# UNITED STATES PATENT AND TRADEMARK OFFICE

APPLICATION NO.	FILING DATE	FIRST NAMED INVENTOR	ATTORNEY DOCKET NO.	CONFIRMATION NO.
10/693,195	10/24/2003	Randall R. Geib	0241-P03282US0	2326

## Office Action Summary

## **DETAILED ACTION**

FIG. 3

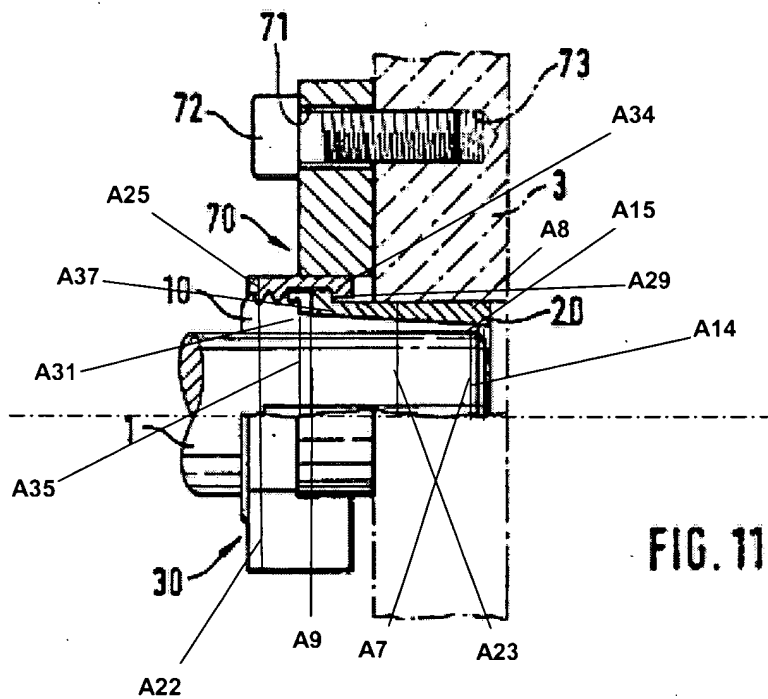
Regarding claim 9, Muellenberg discloses, in Figures 3 and 11, a device, in combination with a machine element **3** having a bore **4**, comprising a one-piece inner sleeve **10**, a nut **30**, and an outer sleeve **20**. The inner sleeve **10** has a forward end **A15** and a rearward end **A31**. The inner sleeve **10** comprises a threaded portion **8**, a frustoconical external surface **6** and an internal bore **5**. The frustoconical external surface **6** has a major diameter **A35** adjacent the threaded portion **8** and a minor diameter **A14** spaced from the major diameter **A35** toward the forward end **A15** of the inner sleeve **10**. The nut **30** has a thread **15** at one end **A25** and a circumferential flange **13** at a distal end **A34**. The outer sleeve **20** engages the machine element **3** and

Regarding claim 1, Muellenberg discloses, in Figures 3 and 11, a device comprising a nut **30**, an outer sleeve **20**, and an inner sleeve **10**. The nut **30** has a thread **15** and a first connector **16**. The outer sleeve **20** comprises an external surface **12**, a tapered internal surface **11**, at least one axial slot **A10** (col. 4, lines 62-64) and a second connector **13**. The tapered internal surface **11** has a minor diameter **A7** adjacent a forward end **A8** of the outer sleeve **20** and a major diameter **A9** spaced rearwardly from the forward end **A8**. The axial slot **A10** extends longitudinally along the outer sleeve **20**. The second connector **13** cooperates with the first connector **16**. The inner sleeve **10** comprises a tapered external surface **6** corresponding in angle of taper to the tapered internal surface **11** of the outer sleeve **20**. The inner sleeve **10** has a minor diameter **A14** adjacent a forward end **A15** of the inner sleeve **10** and a major diameter **A35** spaced rearwardly from the forward end **A15** of the inner sleeve **10**. The

Applicant's Marked-up Figure 2

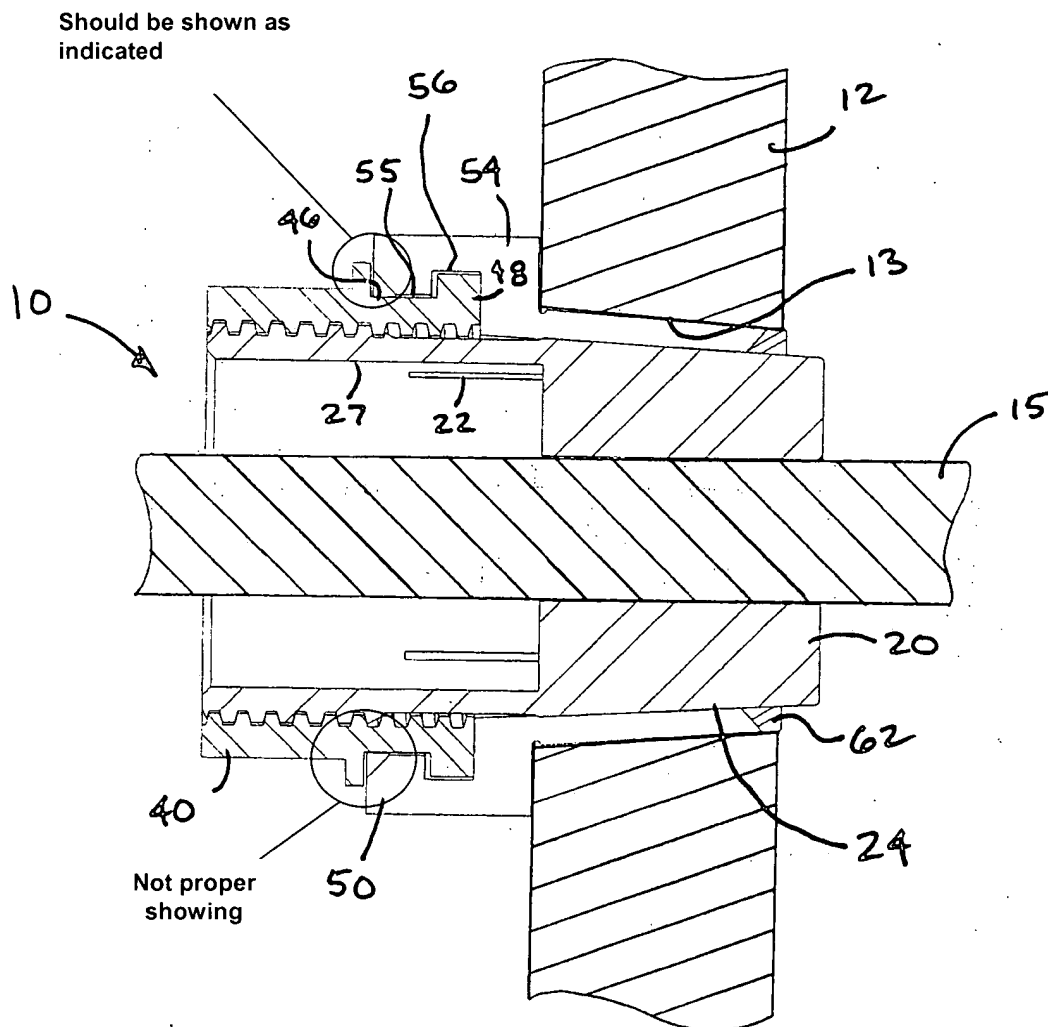
The drawings are objected to because the cross section view of the chamfered surface (unreferenced) of the flange 55 is not shown accurately. See attachment of marked-up Figure 2 to find the cross section view as correctly fixed by the examiner.
